SERVICE BULLETIN

411A

Piper Aircraft Corporation

Subject: Stabilator Torque Tube Bearing Block Attachment Fitting Rivet Replacement

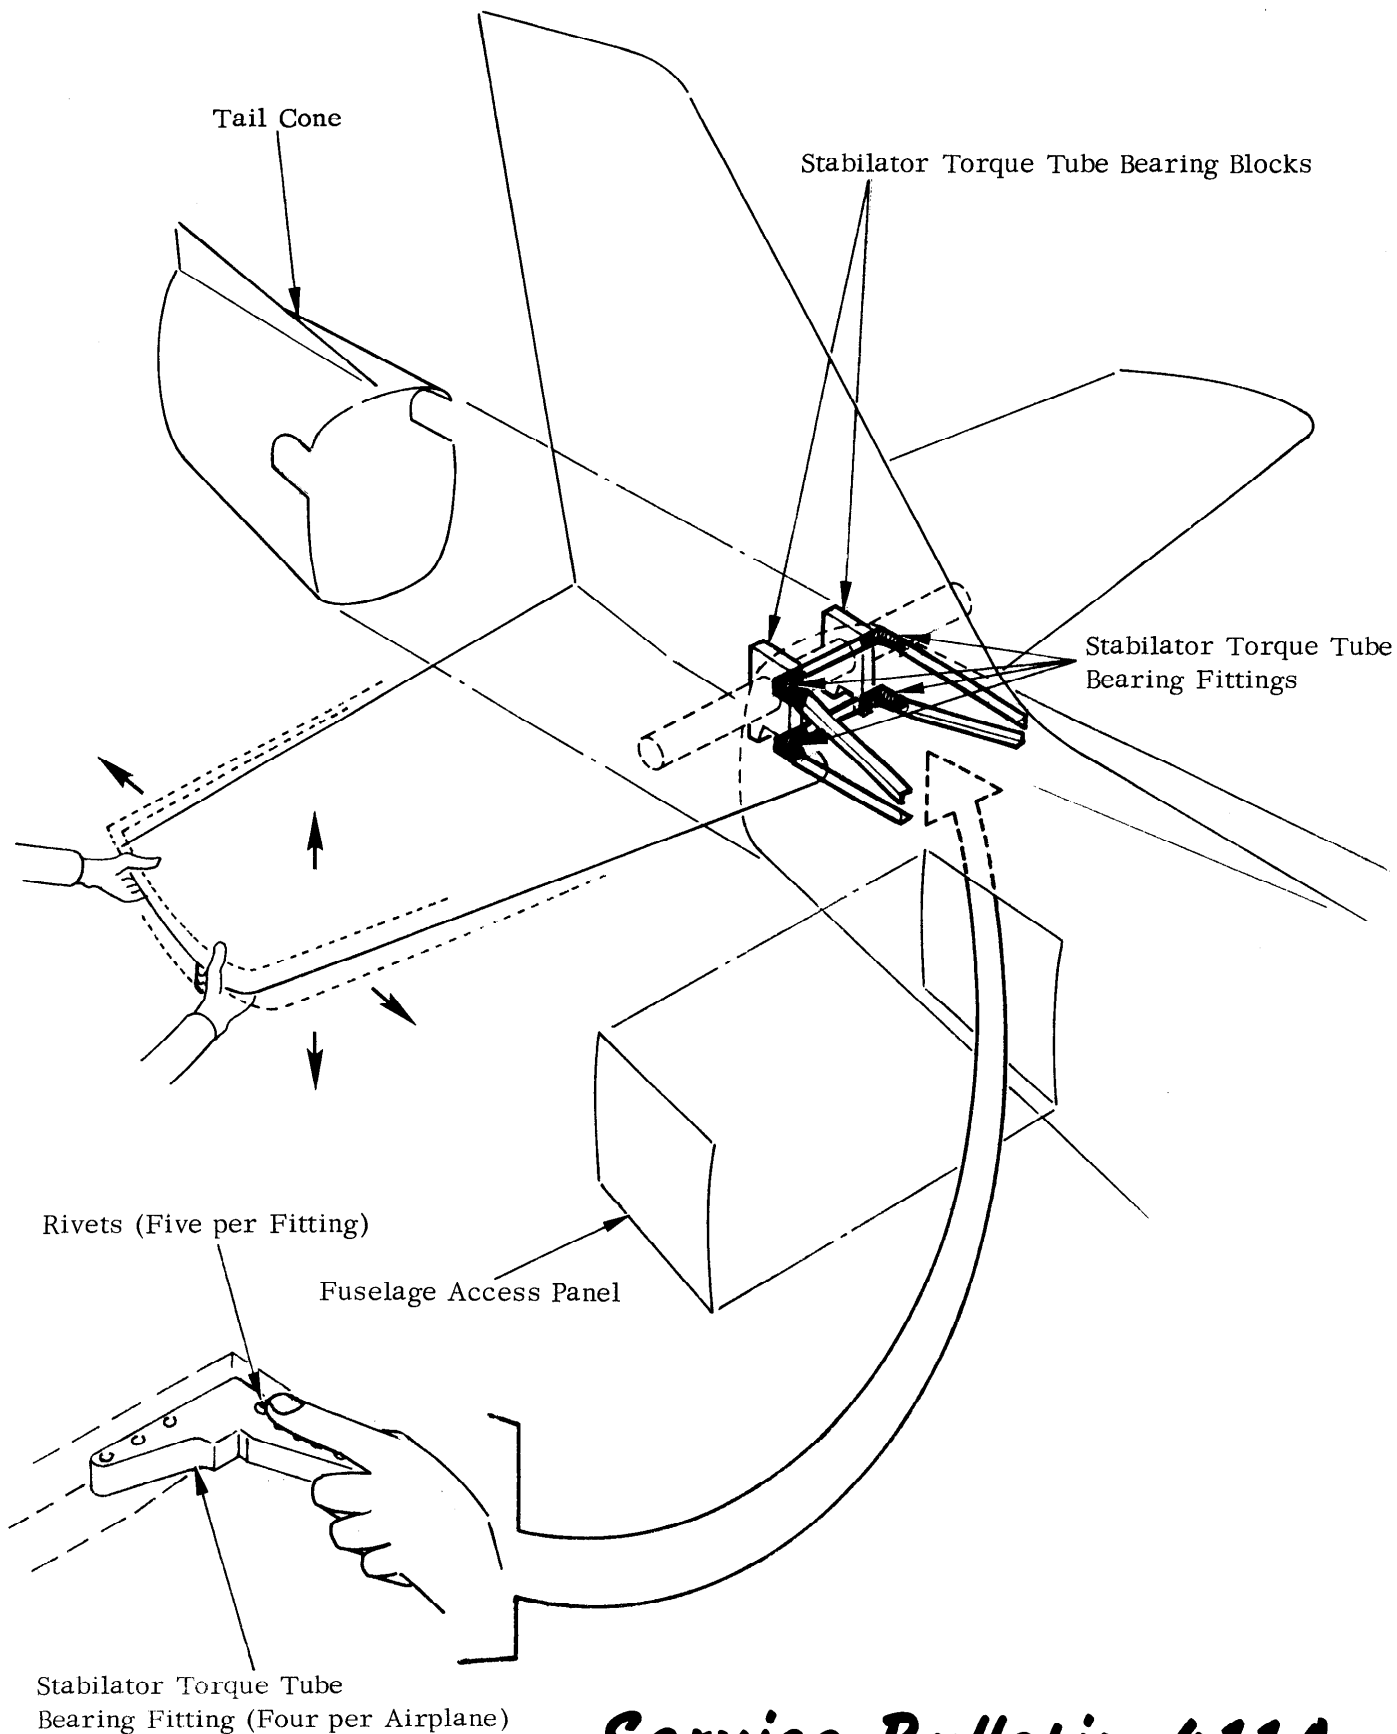
Purpose: Information has been received by the factory describing movement and/or noise in the area where the stabilator assembly joins the fuselage. It has been determined that the above described condition may have been caused by one of the following (refer to attached sketch for a pictorial description of the affected areas):

1. Stabilator torque tube bearings not firmly seated in the stabilator torque tube bearing blocks.
2. The holes in the stabilator torque tube bearing upper and lower fittings may be enlarged.

2. Simultaneously (with Step 1, above), have another person check closely for movement and/or noise in the area described in Purpose, above (the attached sketch illustrates a recommended method of detecting movement in the stabilator torque tube bearing fittings area).
3. If there are no indications of movement and/or noise, no further action is required (other than log book entry).
4. If there is movement and/or noise in the area described in Purpose, above, immediately contact the Customer Services Department, Piper Aircraft Corporation, Lock Haven, Pennsylvania 17745.
